**Notice of Allowability**

10/671,612

TANAKA, AKIHIRO

FIG.1

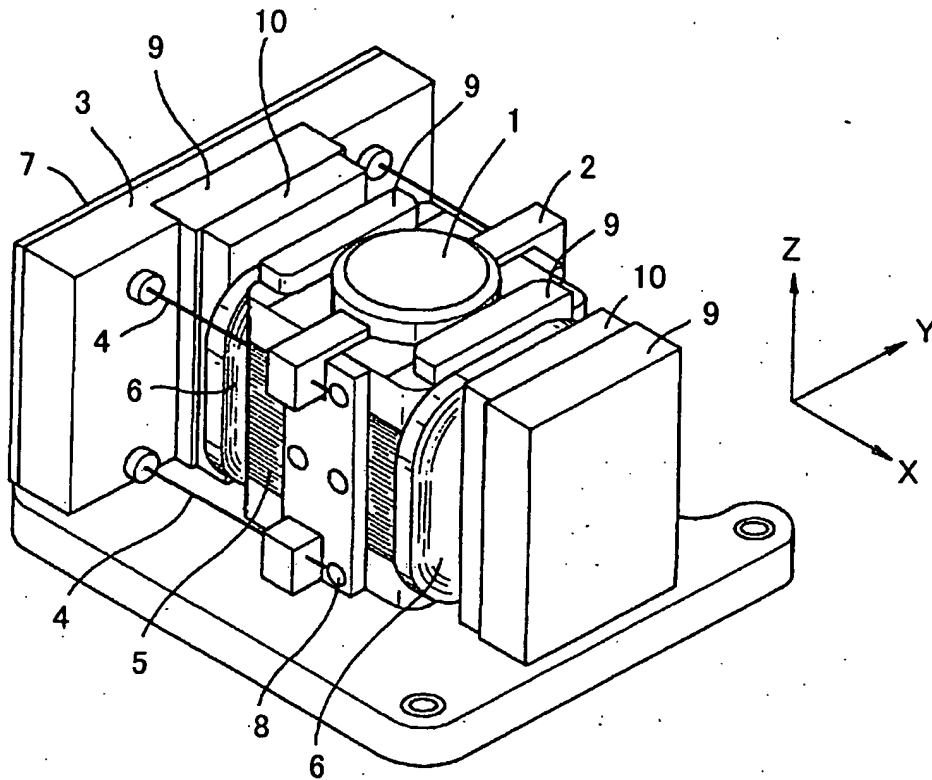
Figure 1 has been labeled as -- Prior Art--.

Prior Art.
